Rezoning Transportation Analysis

Petition Number: 2024-037

General Location Identifier: 07908801, 07908802, 07908805, 07908806, 07908816

Date	Description
4-24-24	First Review (JT)
4-24-24	Second Review (TM)
08-22-24	Third Review (TM)

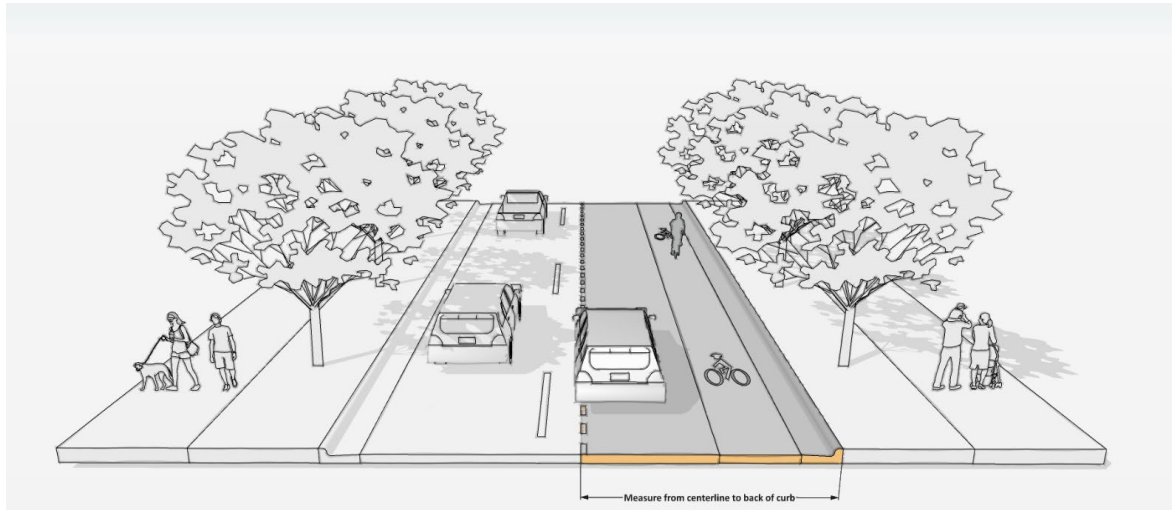
1. Curblines:

- a. ~~Church Street: The future location of curb and gutter is in its existing location.~~

C. THE EXISTING CURB SHALL REMAIN ON BOTH N. CHURCH STREET AND W. 28TH STREET.
D. A RIGHT-OF-WAY ENCROACHMENT AGREEMENT SHALL BE OBTAINED FOR THE INSTALLATI
